FY 2019-20 Standard Plans Update Training

Standard Plans – Update Training

STANDARD PLANS FY 2019-20 REVISIONS LOG

Superelevations – High Speed Roadways, Index 000-510

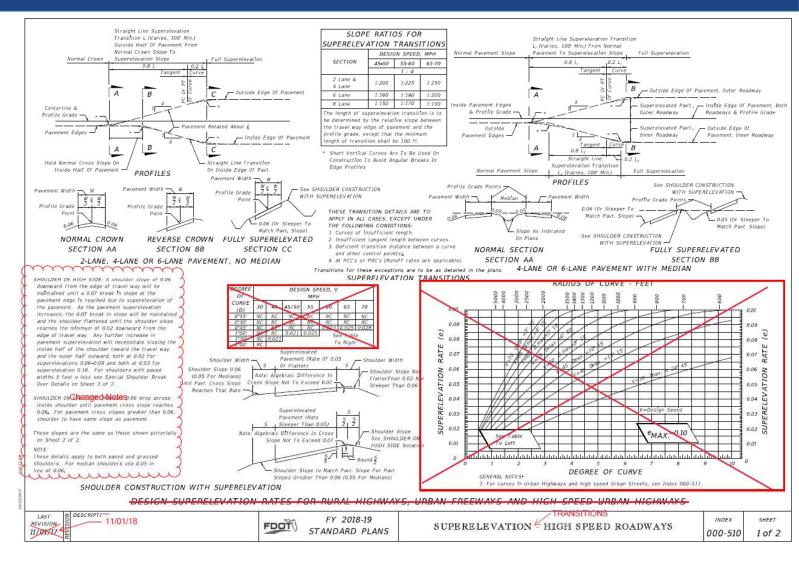
Removed Redundant Information Included in FDM 210.9

Superelevations – High Speed Roadways, Index 000-510

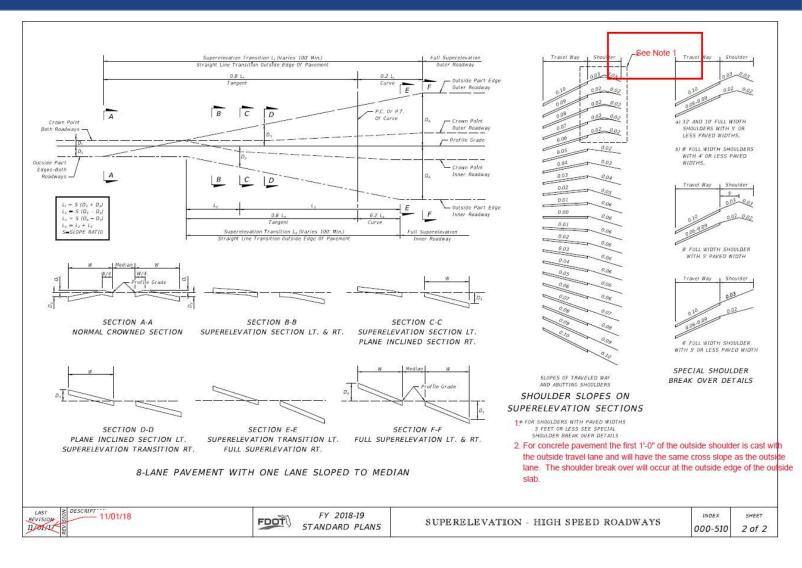
Added Note for Location of Shoulder Break for Concrete Pavement

Superelevations – Low Speed Roadways, Index 000-511

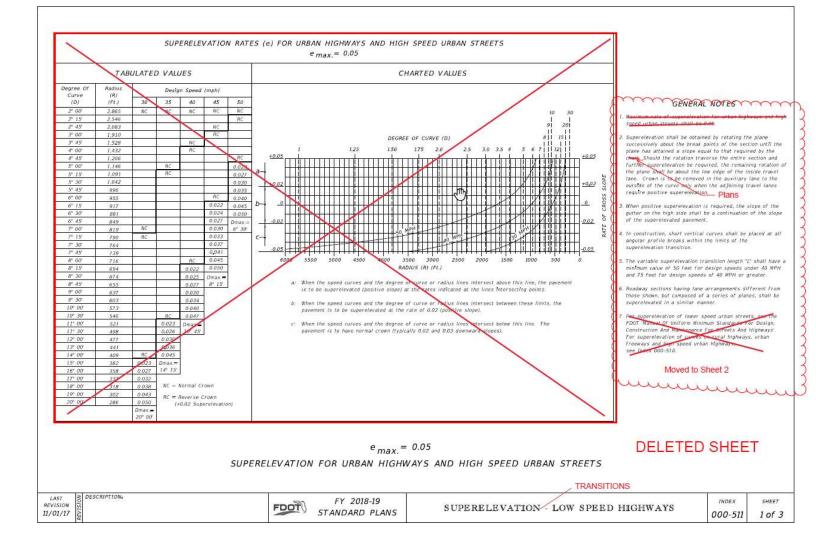
Removed Redundant Information Included in FDM 210.9

NEW - Concrete Flared Driveways, Index 522-003

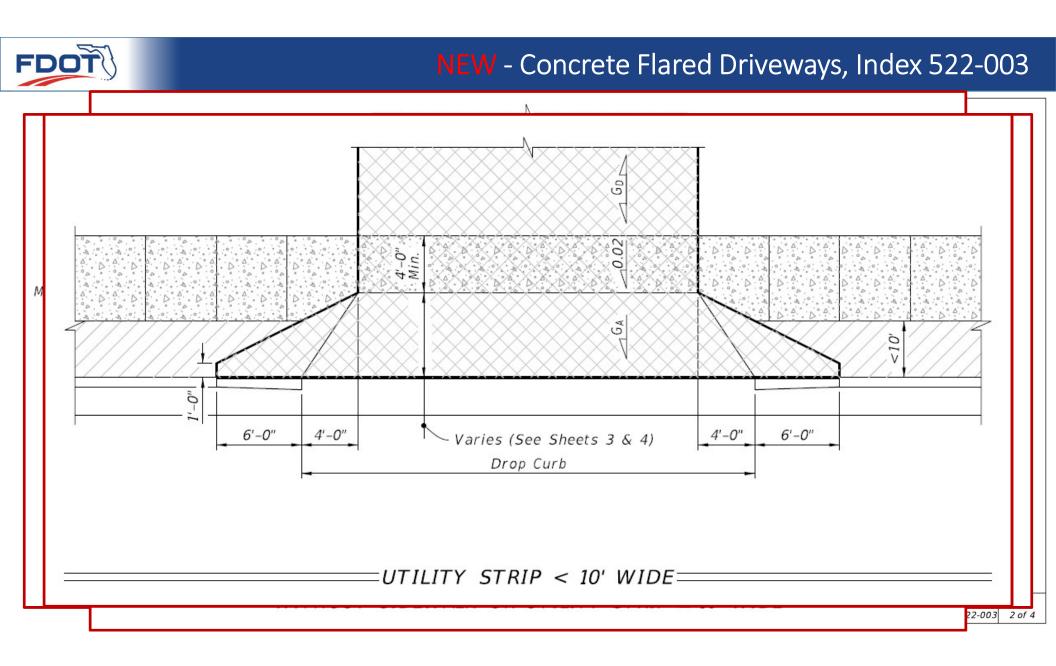
Formatted to Resemble Index 522-002 for Curb Ramps

Construction Information from Sheet 2 of Old Index 000-515

Added Nomenclature Drawings to Define Components

Sheet 9: No More "Type II"!

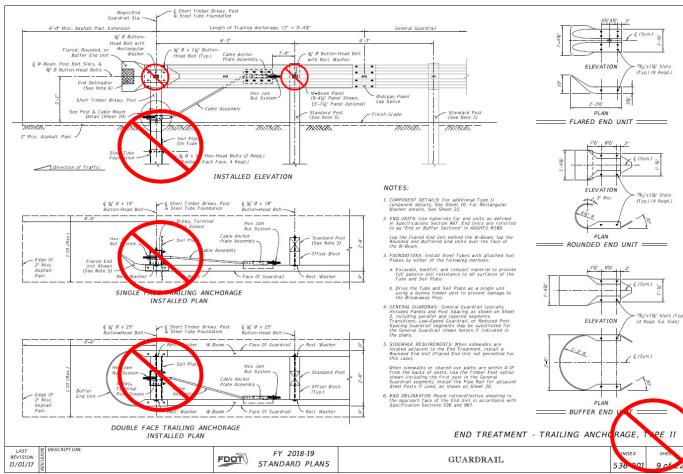
- Soil Plate System Removed
- Rectangular Washers Removed

Sheet 9: New Trailing Anchorage!

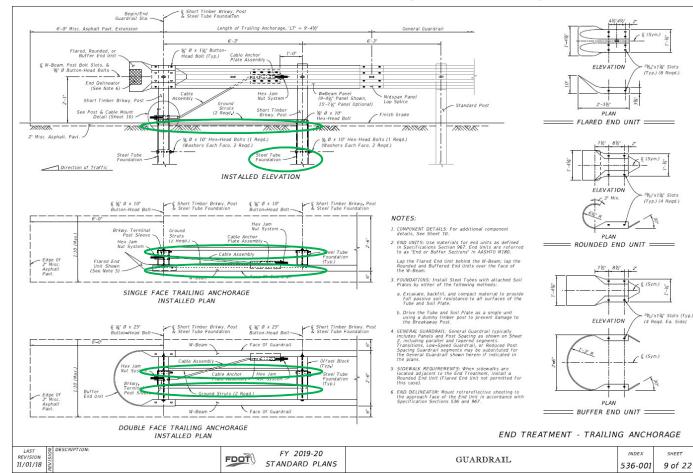
- New Strut System Added
 - 2 Struts Total (1 Each Side)
- New Short Timber Breakaway Post & Steel Tube Foundation at Post 2
- Changes follow latest designs for MASH, following discussions with MwRSF

Sheet 10: New Trailing Anchorage!

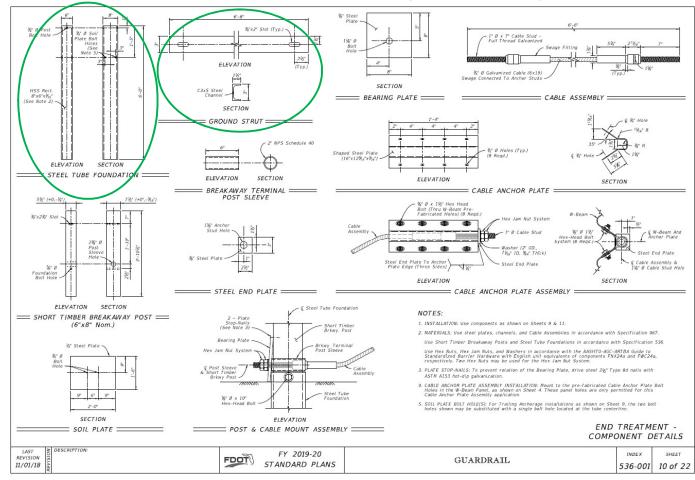
- New Strut System Added
- Steel Tube Foundations lengthened by 1 foot

Sheet 8: New Barrier-Mounted Dual Sign Supports

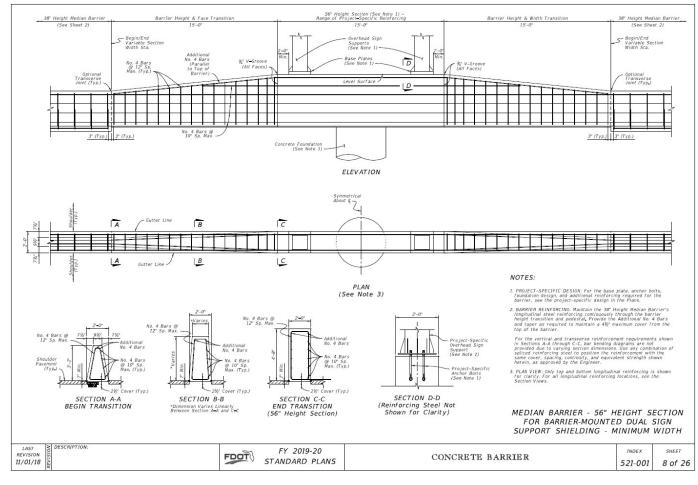
- This is an alternative to larger sign supports with barrier widening
- Design is for <u>least use</u> <u>of space</u>
- <u>No shoulder reduction:</u> Barrier Gutter Lines remain at 2 foot barrier width

Sheet 1: Redeveloped OVB – New Heights and Features

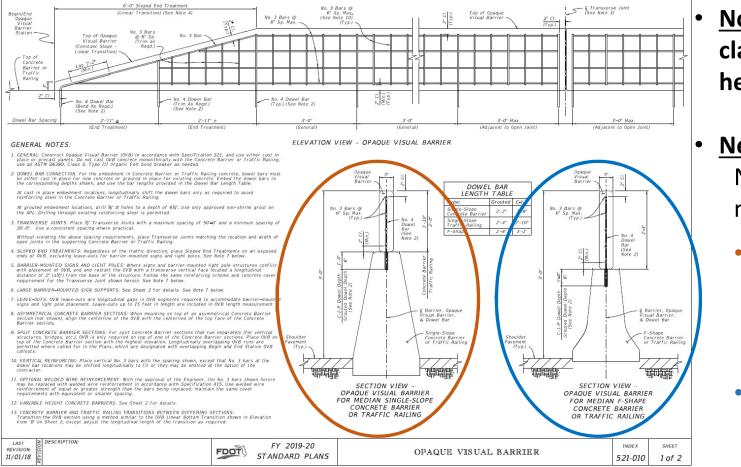
- <u>Notes rewritten</u> for clarity with new headings
- <u>New OVB Heights</u>: Now accommodates multiple cases:
 - New Single-Slope Concrete Barrier & Bridge Traffic Railing
 - Old F-Shape Barrier (Existing)

General Information for Traffic Control Through Work Zones, Index 102-600

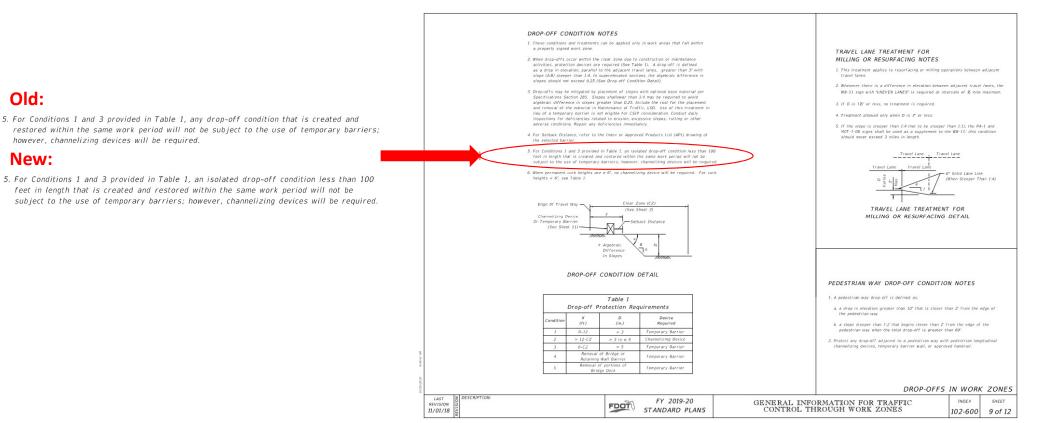
Changed the maximum lane closure length to three miles for highspeed facilities

Tourist Oriented Directional Signs, Index 700-103

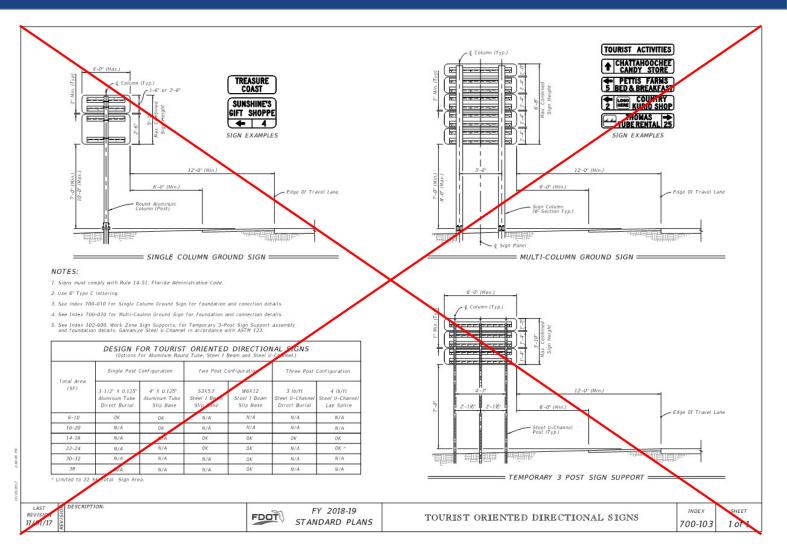
Deleted Index and moved the details into FDM 230.2.10.

Enhanced Highway Signing Assemblies, Index 700-120

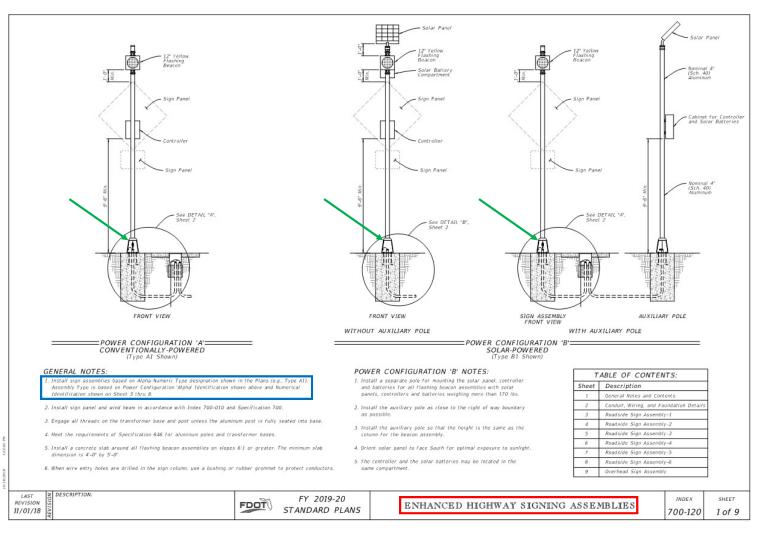
There are Index-wide changes. The primary revisions are the following:

- Changed title to "Enhanced Highway Signing Assemblies"
- The removal of RRFBs to separate Index 654-001
- An alpha-numerical system for easy identification
- The addition of highlighted signs
- The use of pedestals for all roadside signs

Typical Placement of Raised Pavement Markers, Index 706-001

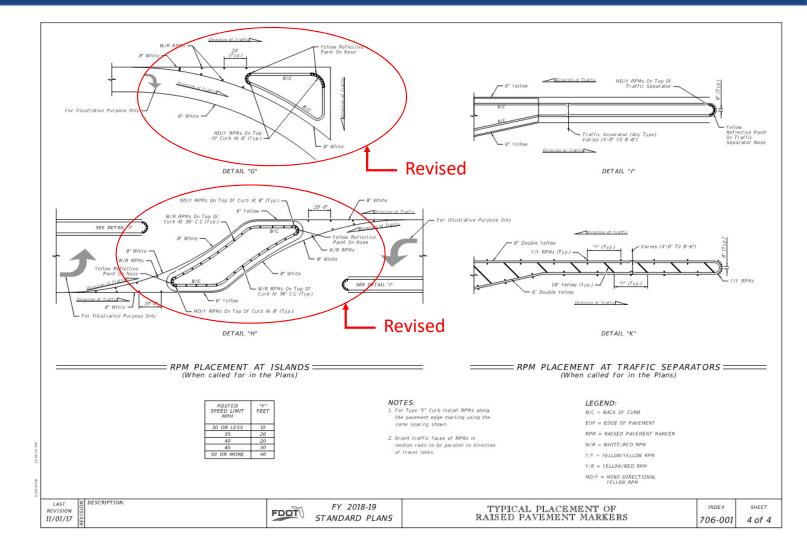
Revised RPM and Reflective Yellow Paint placement.

Typical Placement of Raised Pavement Markers, Index 706-001

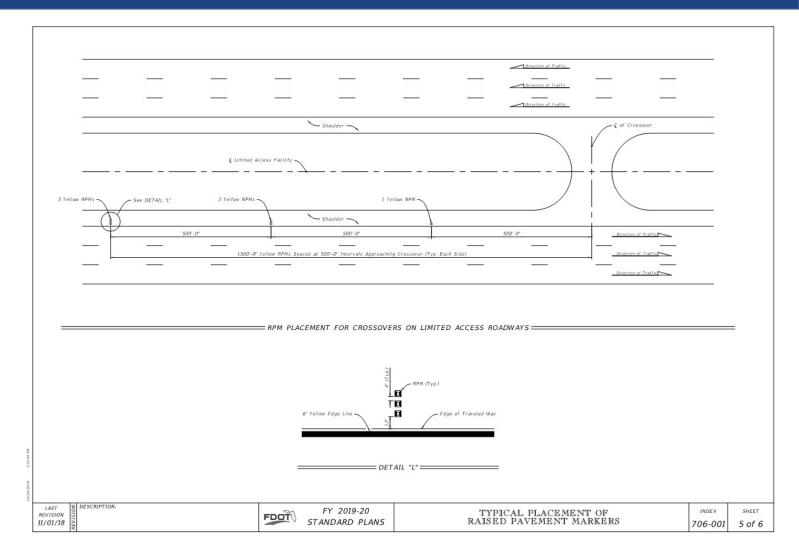
Added sheet showing the placement of RPMs at Limited Access crossovers. This information was previously in FDM 211.3.2.

Typical Placement of Raised Pavement Markers, Index 706-001

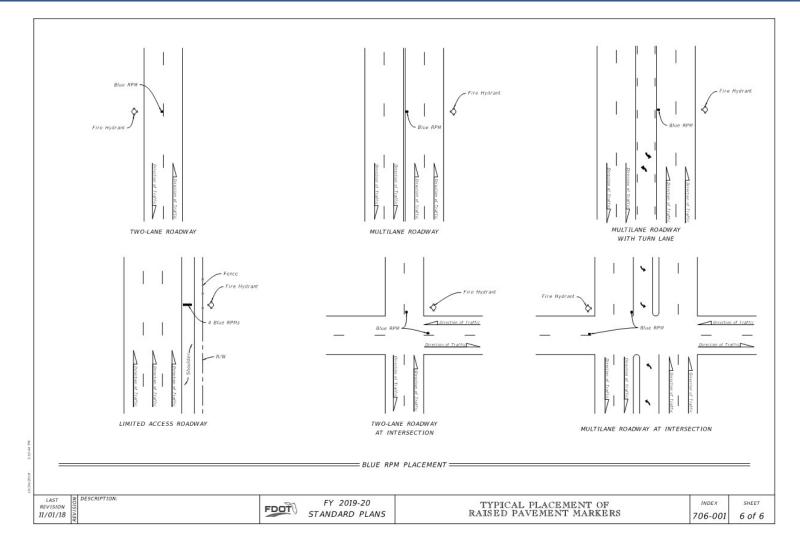
Added sheet showing the placement of blue RPMs. This information is currently in TEM Section 4.3.

Pavement Markings, Index 711-001

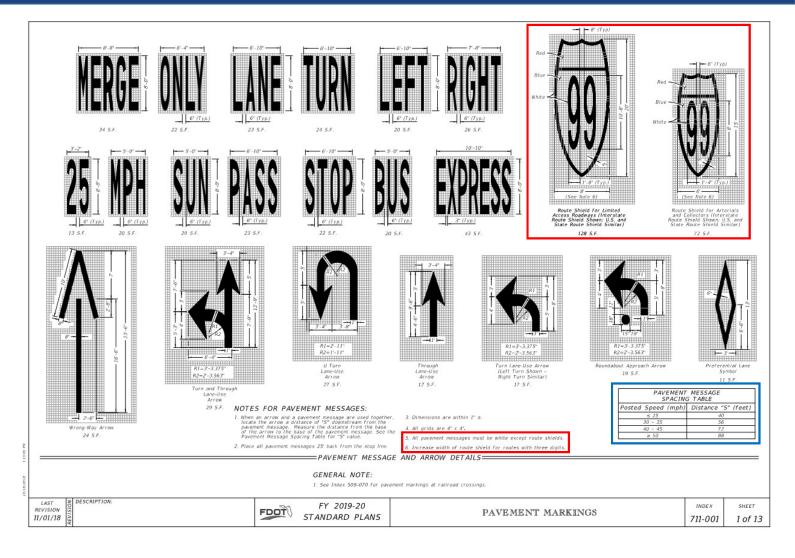
Significant changes on Sheet 1 are the following:

- Added standard details for route shields
- Added pavement message spacing table

Sheet 10 of 13

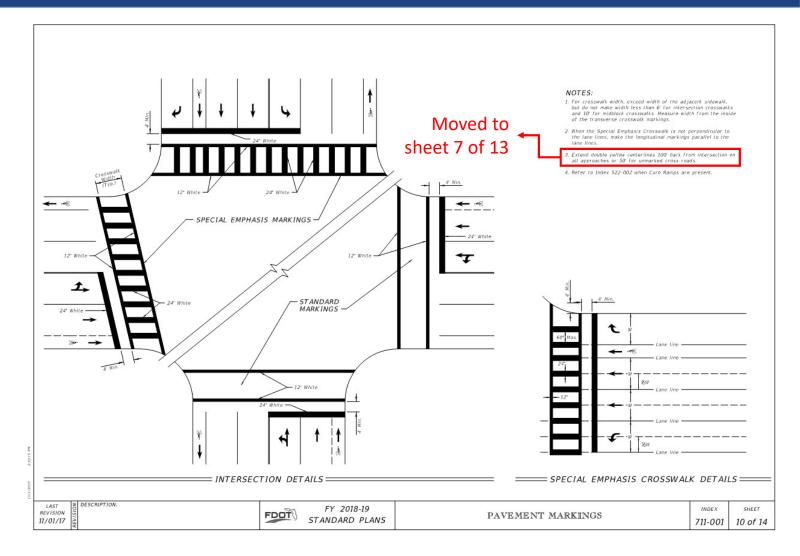
Revised sheet to show only basic crosswalk pavement marking details.

Old Sheet 12 of 14

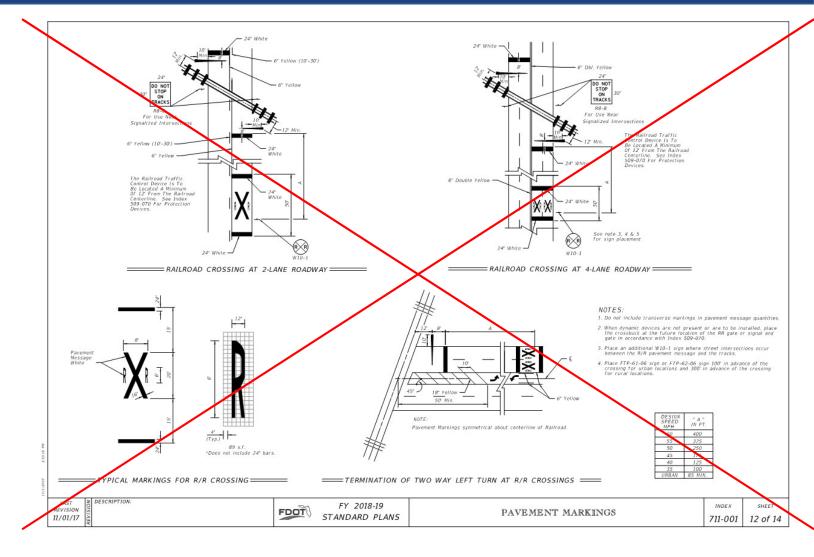
This sheet has been deleted. See Index 509-070 for pavement markings at atgrade railroad crossings.

Sheet 4 of 8

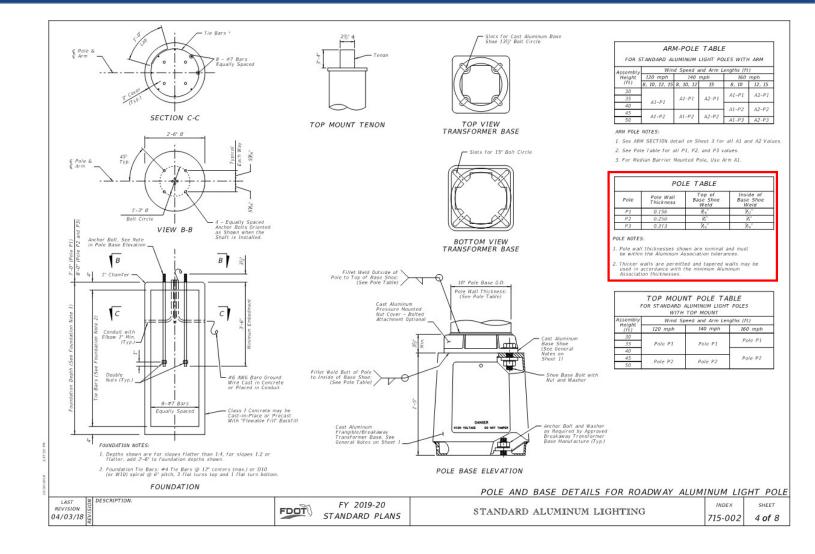
Pole wall thicknesses have been revised!
